# **Draft Final Scope of Work to Prepare a Draft Environmental Impact Statement for the Gowanus Canal Combined Sewer Overflow (CSO) Facilities Project**

## **Appendix A: Response to Comments on the Draft Scope of Work**

Head End Facility Alternative Site  
**Figure 6**

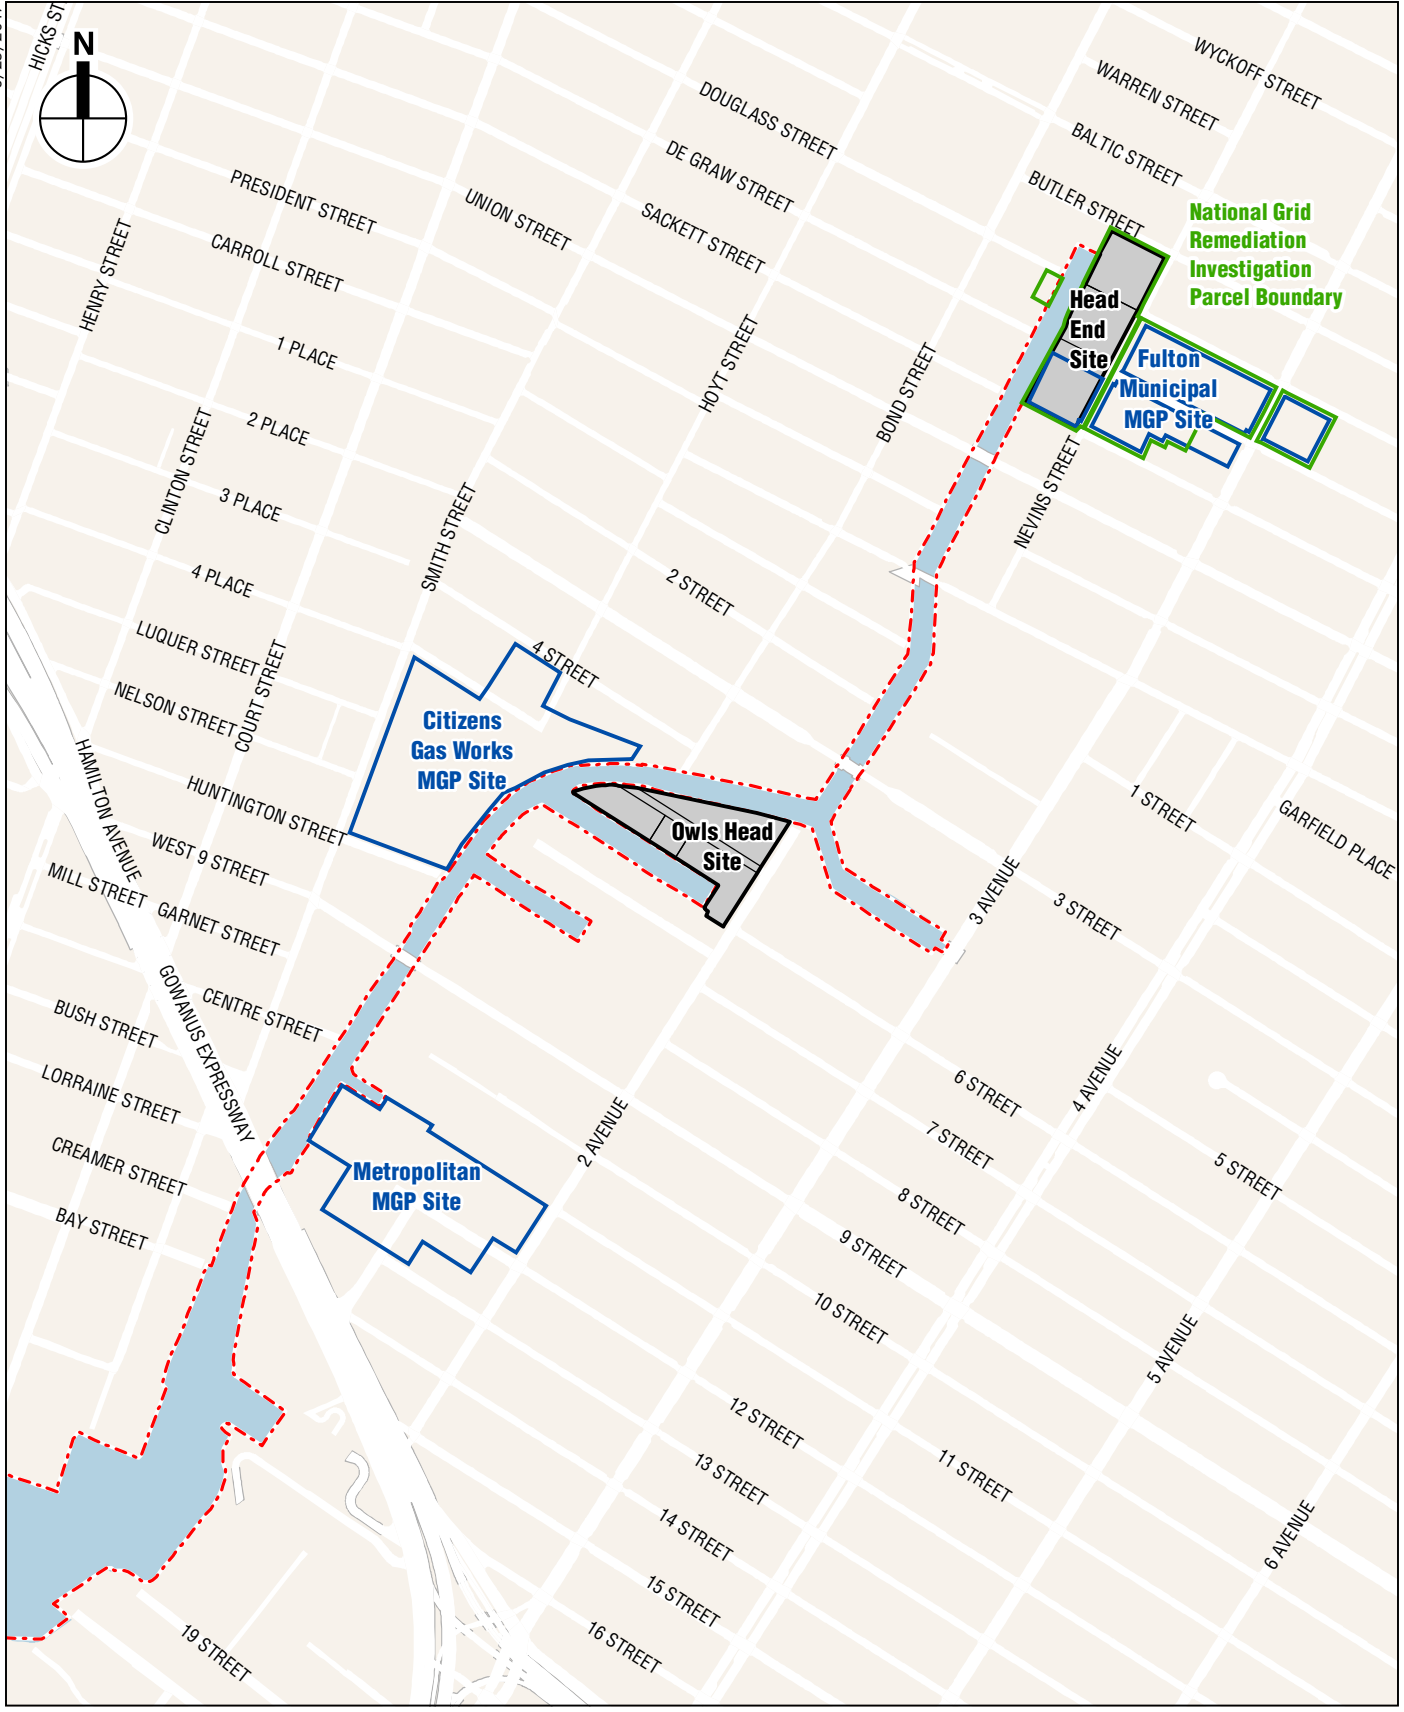
Figure 6 of the DSOW indicates that DEP is considering the entire Park as an alternative site. However, prior comments by DEP indicate that only a portion of the Park would be used, and that effort would be made specifically to retain the tree cover on the southeastern end of the property. The EIS should specify how much of the Park would be impacted or made permanently unavailable by the Head End facility if this alternative is selected. The EIS should also consider at least one alternative which maximizes post-project availability of the Park.
